Work Order ID 141872

Item Name: Baggage Compartment Protector - Floor And Wall

DART SERVICE INSTRUCTION

TO AMEND INSTALLATION INSTRUCTIONS IIN-D407-781-2 REV. A OR LATER APPROVED REVISION
AND INSTRUCTIONS FOR CONTINUED AIRWORTHINESS ICA-D407-781 REV. 3 OR LATER REVISION

**FIGURE 1 - D3879-1 BAGGAGE COMPARTMENT WALL
PROTECTOR - ALTERNATE INSTALLATION**

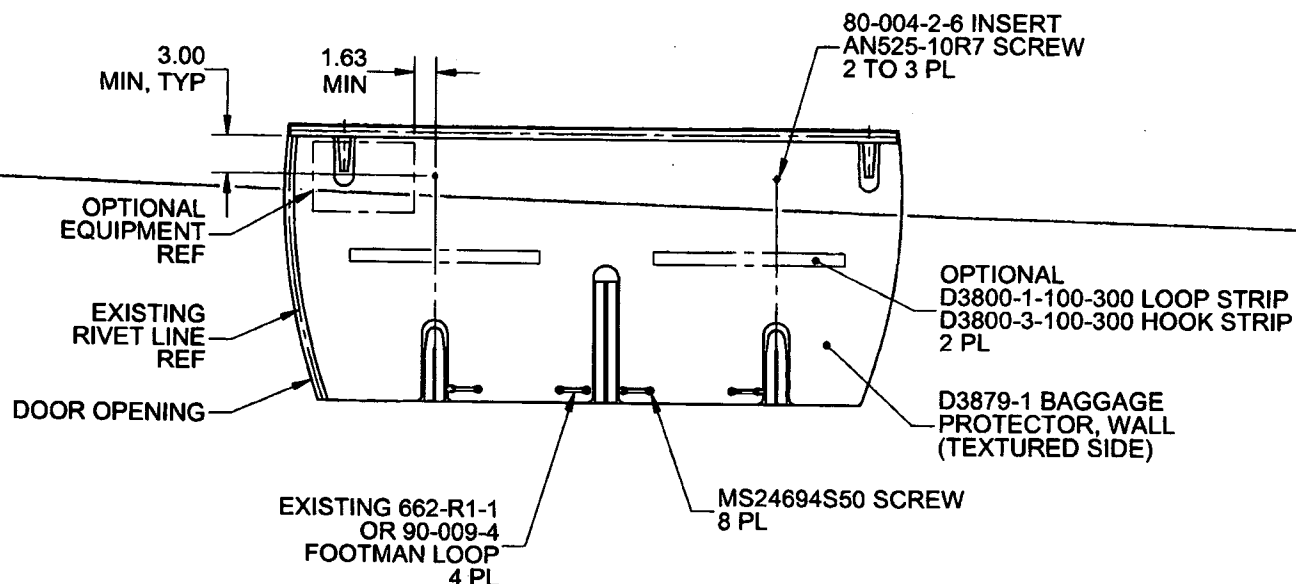
In some aircraft, the top portion of the D206-781-041 Baggage Compartment Wall Protector Kit cannot be installed as indicated in IIN-D407-781-2. The purpose of this DSI is to provide an alternate mounting method to fasten the top portion of the D206-781-041 Baggage Compartment Wall Protector Kit.

It is acceptable to replace qty(2) D3930-1 Clips with qty(2) 80-004-2-6 Inserts. Locate and mark location of the two attachment holes on the baggage compartment wall as shown in Figure 1 of this service instruction. Install 80-004-2-6 Inserts at the marked locations in accordance with Section 3-2-12 of BHT-206-SRM-1. It is acceptable to trim the wall protectors to accommodate optional equipment or transfer attachment holes to the wall protector and install the optional equipment on top of the wall protector with longer fasteners.

Amend the D206-781-041 Baggage Compartment Wall Protector Kit parts list as follows:

Qty -061	Qty -031	Qty -041	Part Number	Description
X			D206-781-061	BAGGAGE COMPARTMENT PROTECTOR KIT (FLOOR AND WALL)
1	X		D206-781-031	BAGGAGE COMPARTMENT FLOOR PROTECTOR KIT
1		X	D206-781-041	BAGGAGE COMPARTMENT WALL PROTECTOR KIT
		2	AN525-10R7	SCREW
		2	80-004-2-6	INSERT
